ADDENDUM | No. 2

PROJECT	WEB Water Treatment Plant Improvements - 2022
BID DATE	1:00 PM Central Time Zone September 12, 2022
BID LOCATION	WEB Water Office 38456 W US Hwy 12 Aberdeen, SD 57401
ISSUE DATE	September 8, 2022
NOTICE	Failure to acknowledge all addenda in the BID may cause rejection of the BID. See Instructions to Bidders.

UPPER LEVEL PIPING PLAN

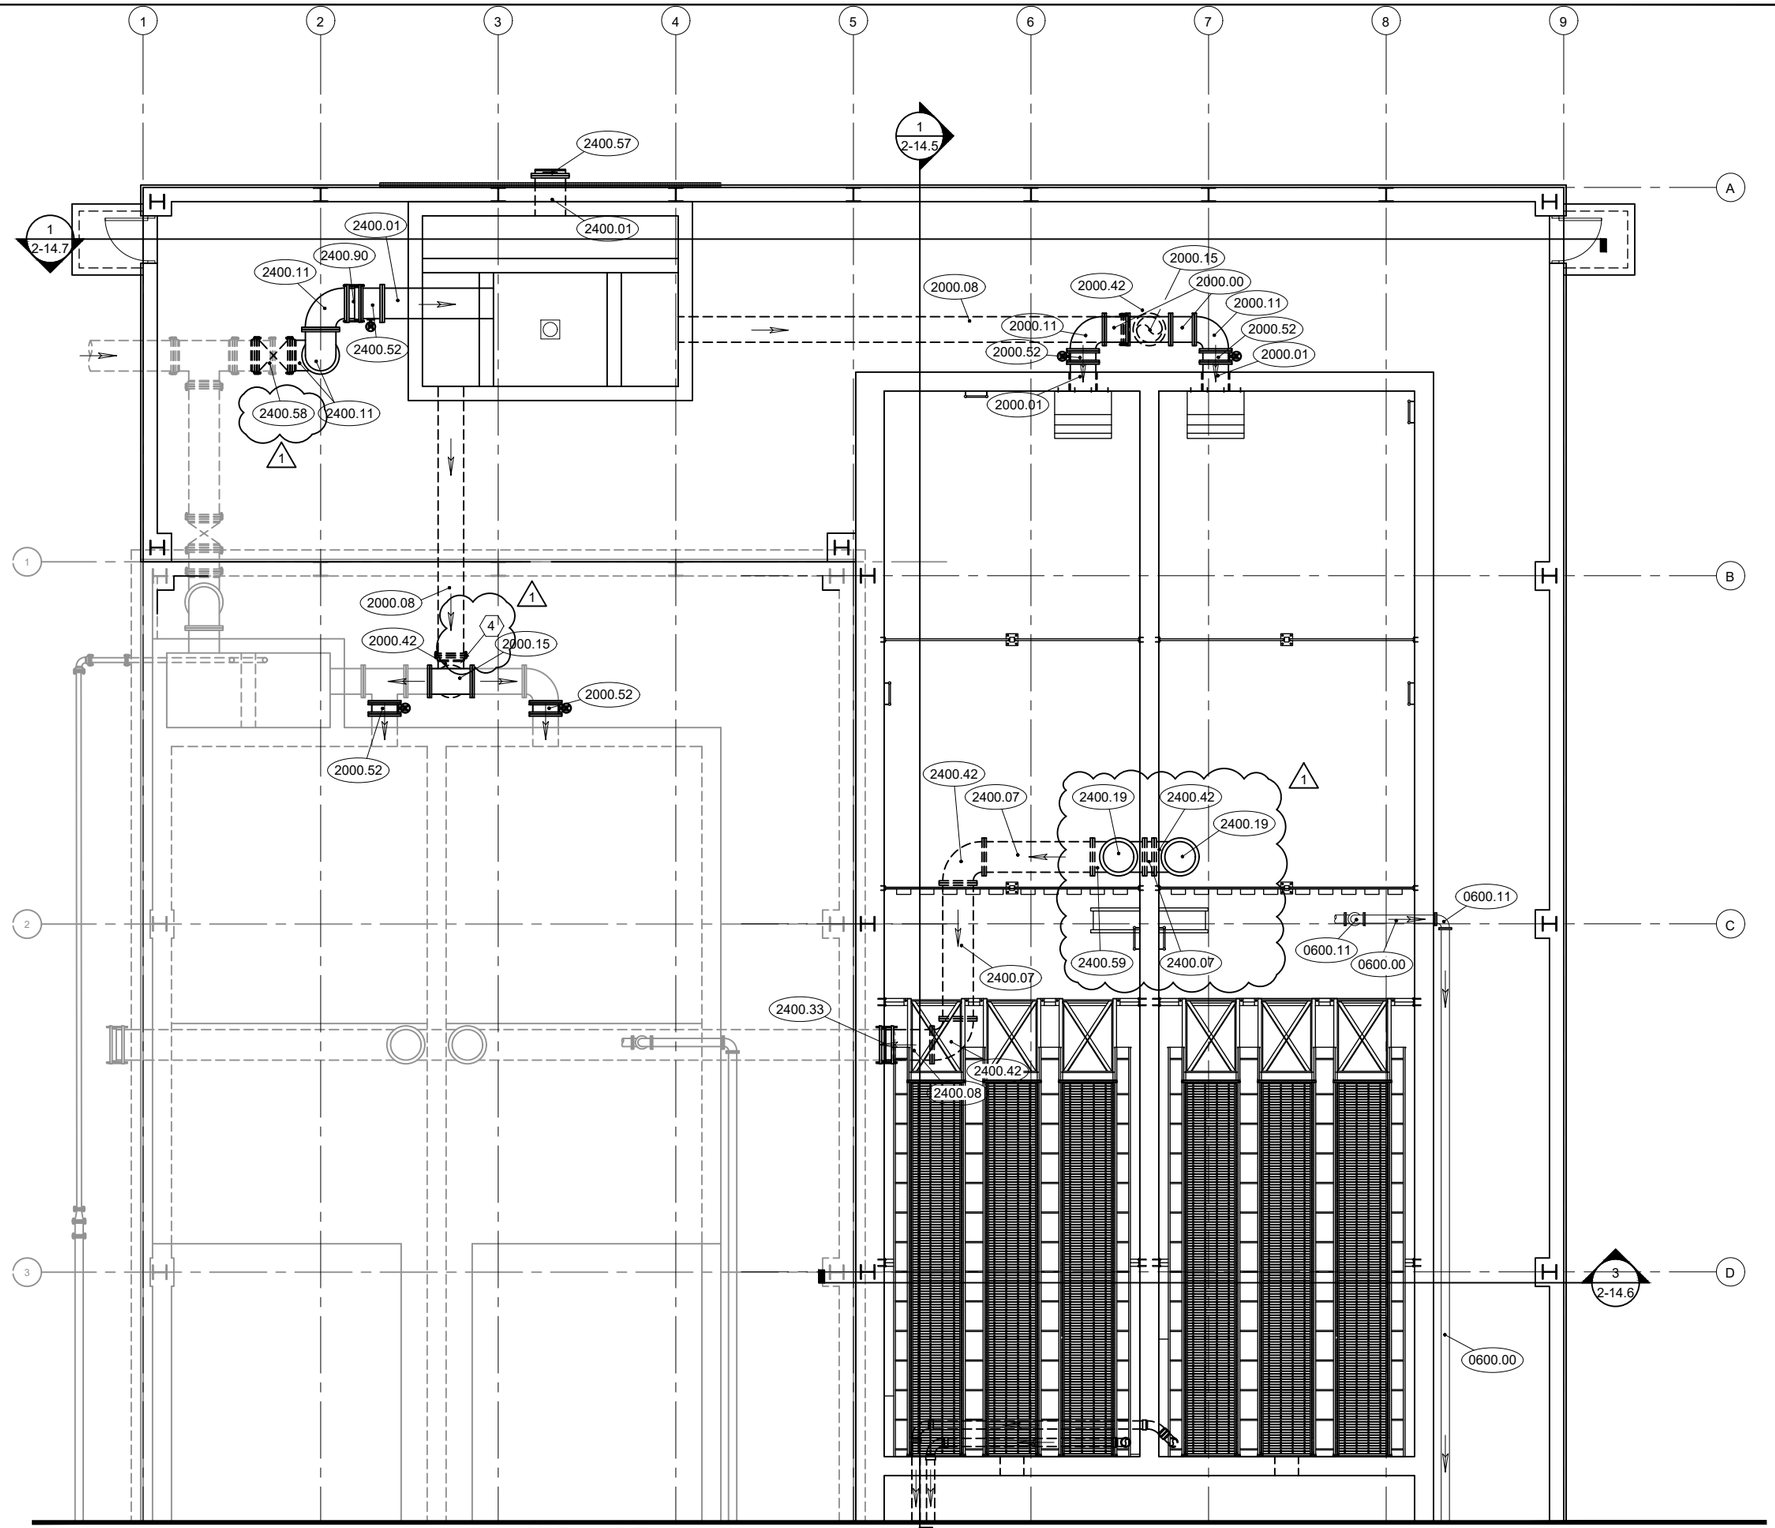
Revised piping tags. Added Note 5. Revisions on Sheet 2-14.1 shall also apply to Sheet 2-14.3 and Sheet 2-14.7.

1 NEW PUMP / PIPING SECTION
4-14.4 SCALE : 1/8" = 1' - 0"

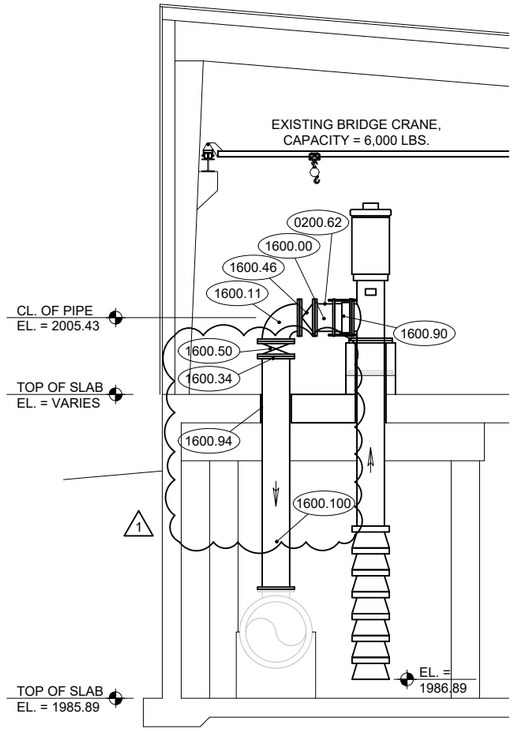
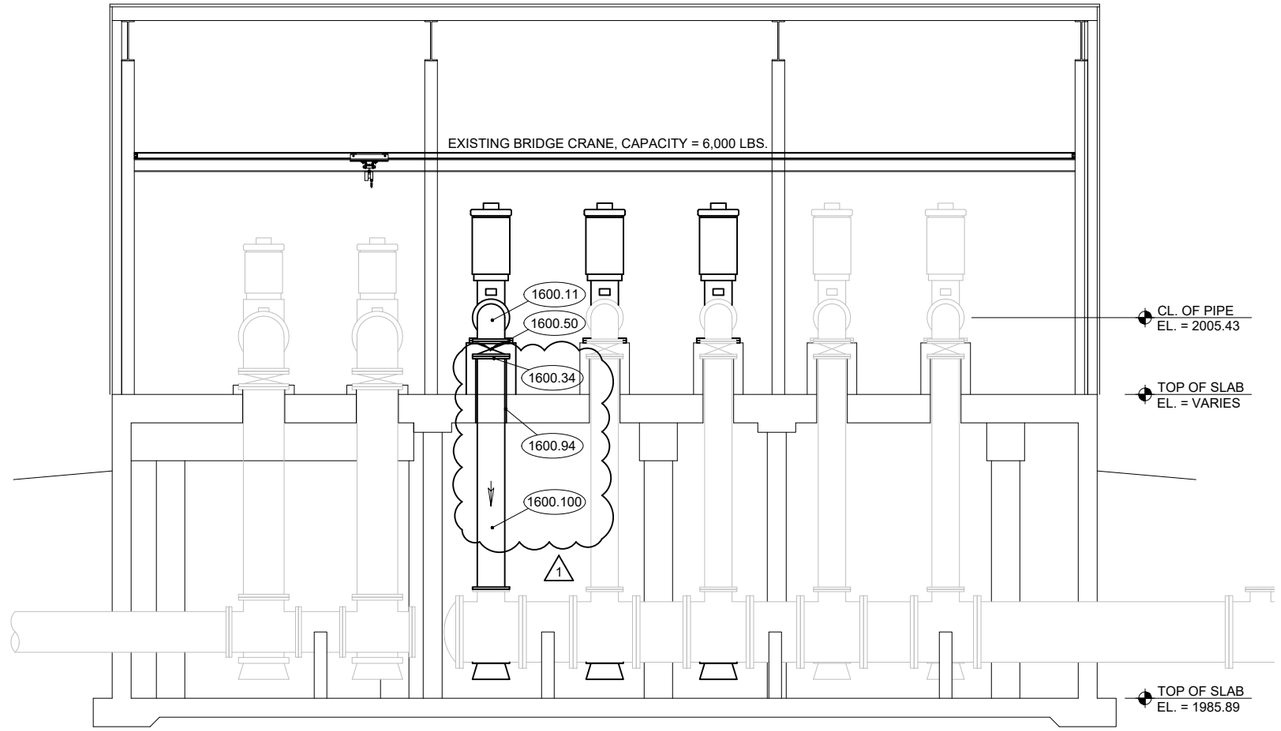
Revised piping tags.
